HISTORIC AND DESIGN REVIEW COMMISSION

HDRC CASE NO: 2017-645
ADDRESS: 714 DAWSON ST
LEGAL DESCRIPTION: NCB 570 BLK 6 LOT 4
ZONING: RM-4 H
CITY COUNCIL DIST.: 2
DISTRICT: Dignowity Hill Historic District
APPLICANT: Eddie Lowrance
OWNER: Eddie Lowrance
TYPE OF WORK: front yard fence, landscaping, driveway expansion
APPLICATION RECEIVED: November 30, 2017
60-DAY REVIEW: January 29, 2018
REQUEST:

The applicant is requesting a Certificate of Appropriateness for approval to:

114 DAWSON 6 FOOT CHAIN LINK FENCE PRIOR TO
RENOVATION

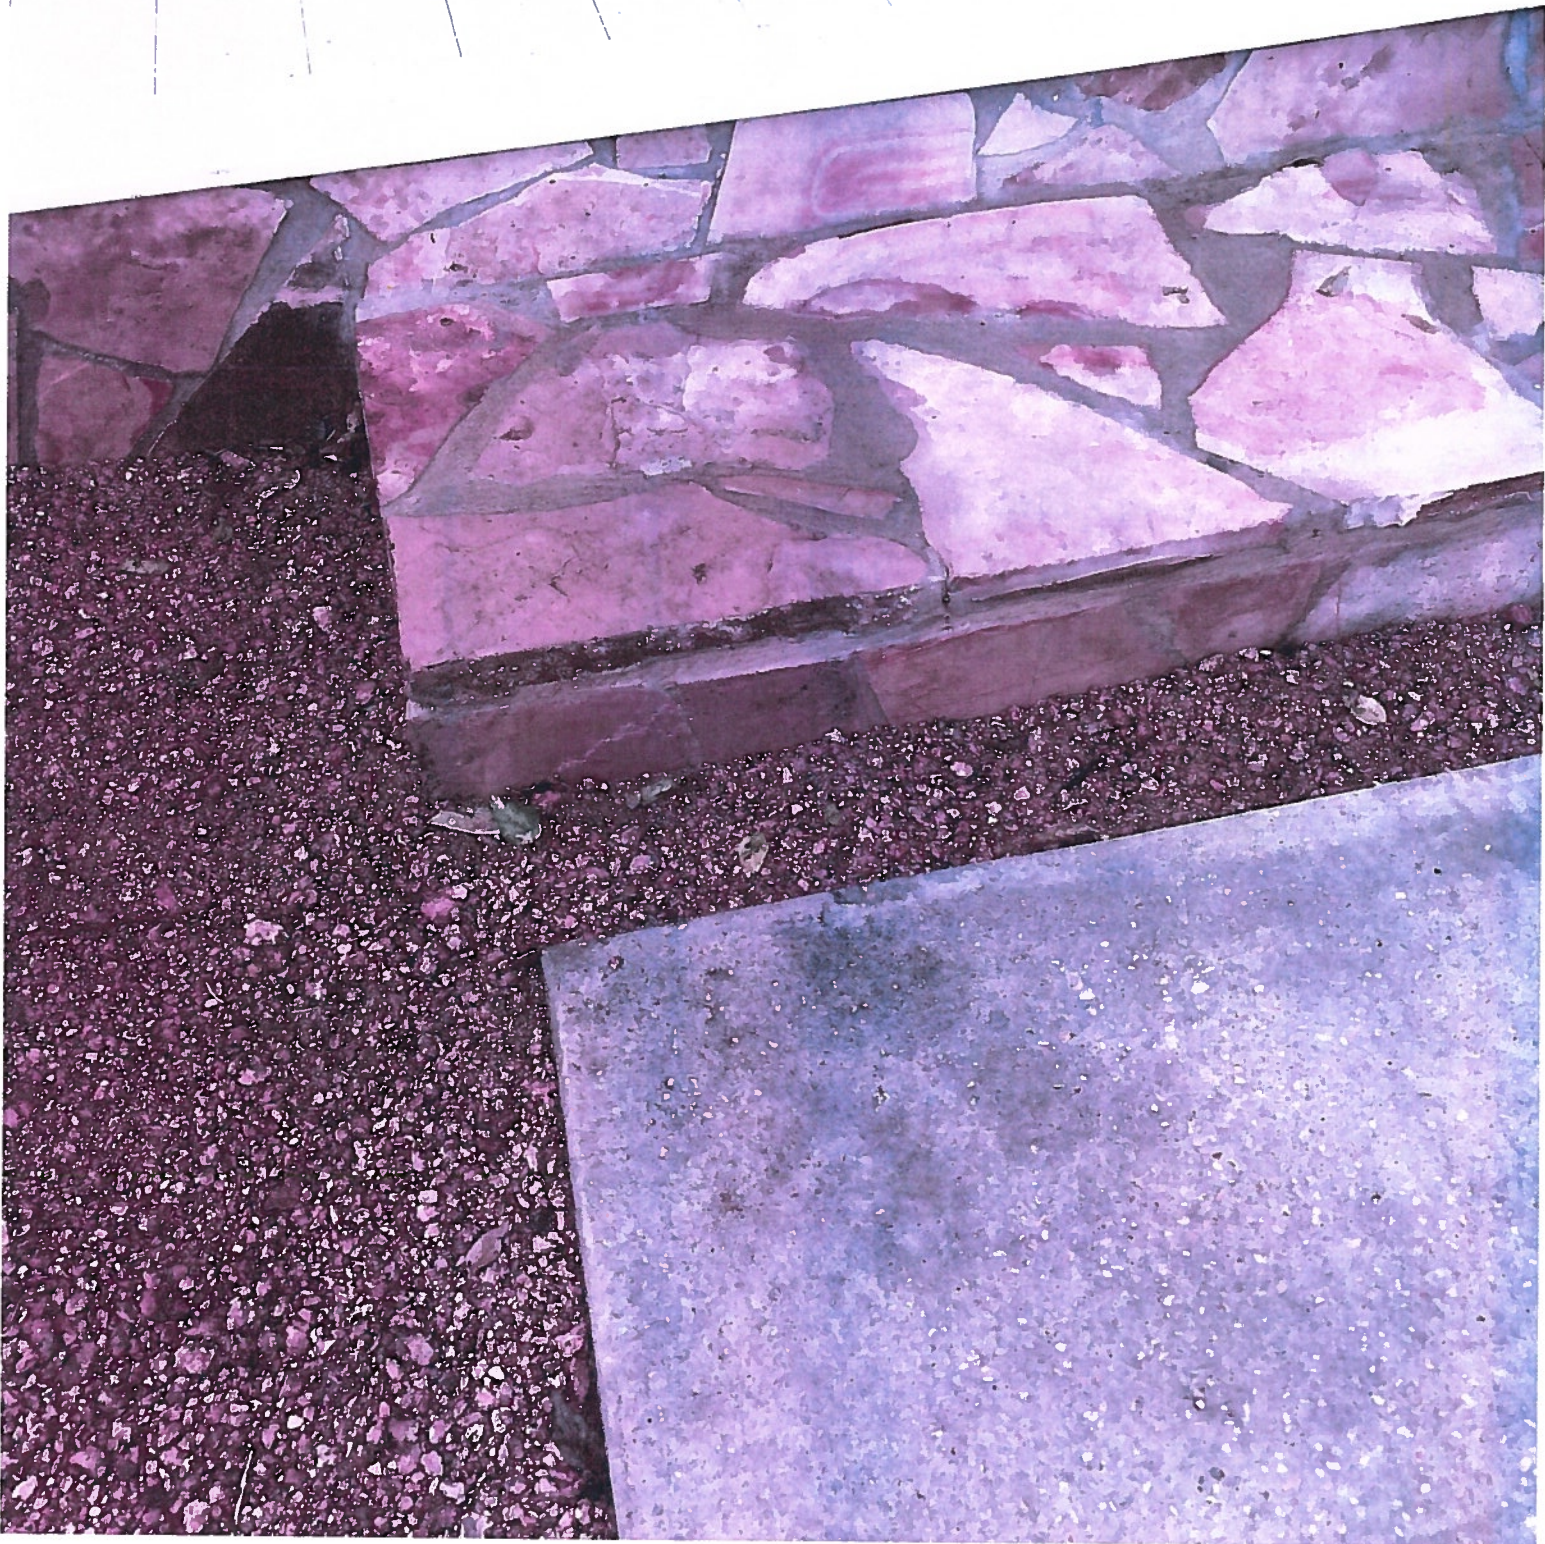
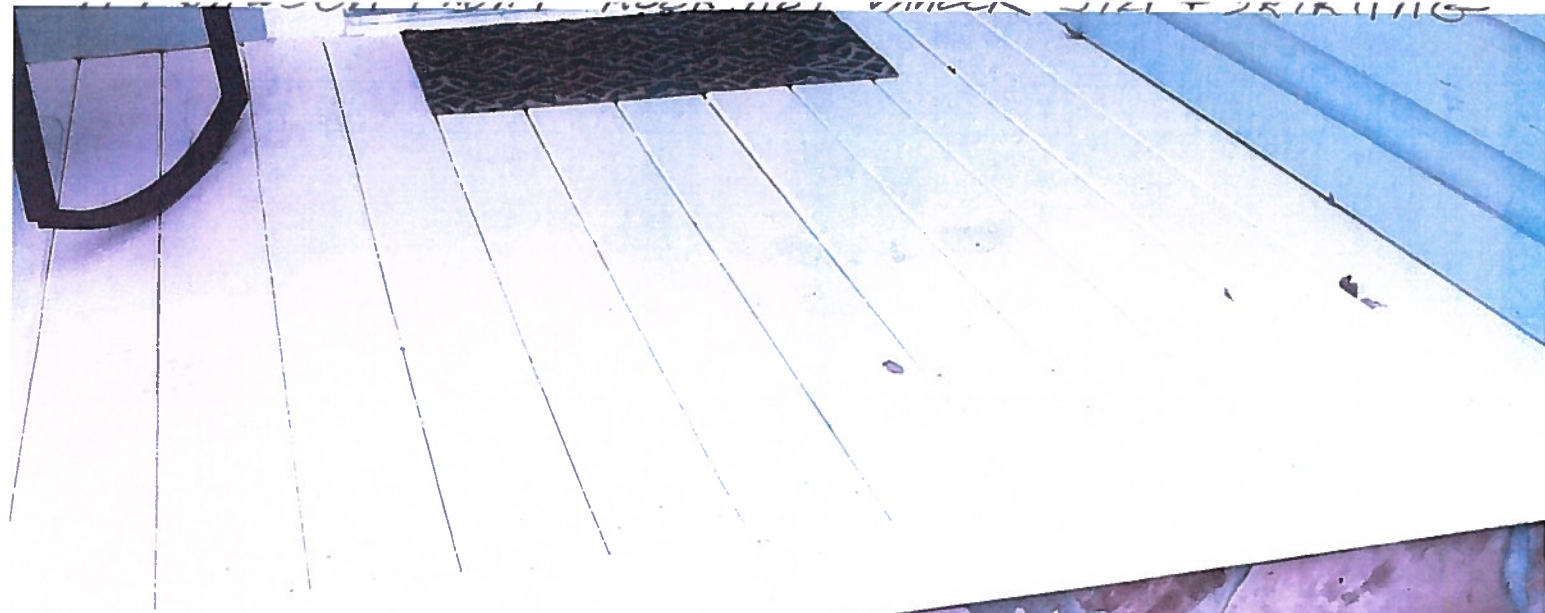
- b. FENCE – The applicant has proposed to install a front yard wrought iron fence to feature a total height of six (6) feet in height. Because a non-original fence was already located on the property, and the two adjacent properties also feature non-original fences, staff finds the replacement of this fence with new material to be appropriate. However, any replacement must meet with the Historic Design Guidelines and development standards related to front yard fencing. Staff finds the proposed replacement fence is appropriate provide it be reduced to no more than four (4) feet in height and returns to the corner of the historic structure rather than runs across the driveway.

- i. Staff recommends approval of the installation of a front yard fence based on finding b with the stipulation that the height be reduced to 4 feet and that it returns to the corner of the historic structure rather than run across the driveway. The driveway gate should be eliminated or relocated behind the front plane of the historic structure.
- ii. Staff does not recommend approval of the front porch modifications based on finding c.
- iii. Staff does not recommend approval of the walkway modifications. Staff recommends that the applicant restore the stepping pads to the simple, paved concrete walkway that follows the established development pattern.
- iv. Staff recommends approval of the front yard modifications with the stipulation that more plantings are installed to meet the Guideline's standards for xeriscaping.
- v. Staff recommends approval of lengthening the driveway.

714 DAWSON DRIVEWAY
11 FEET 3 inches wide.

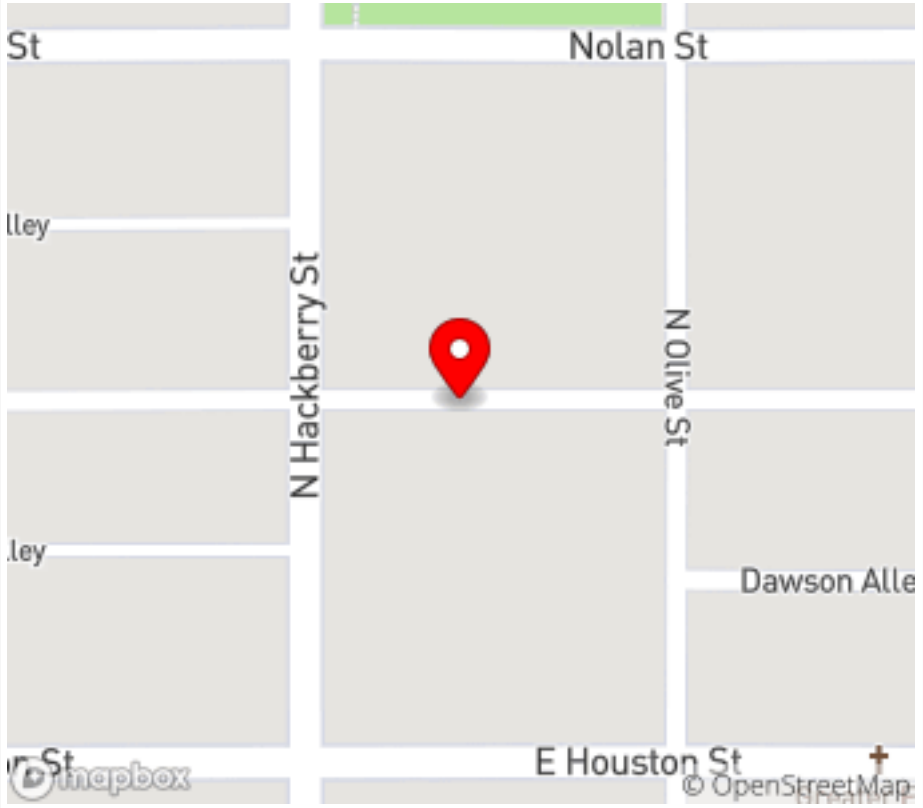
- f. DRIVEWAY AND PARKING PAD – The applicant has proposed to lengthen the existing concrete driveway to include a parking pad adjacent to the house. Per the Guidelines for driveways 5.B.i., new driveways should incorporate similar material, width, and design to those historically found on site or
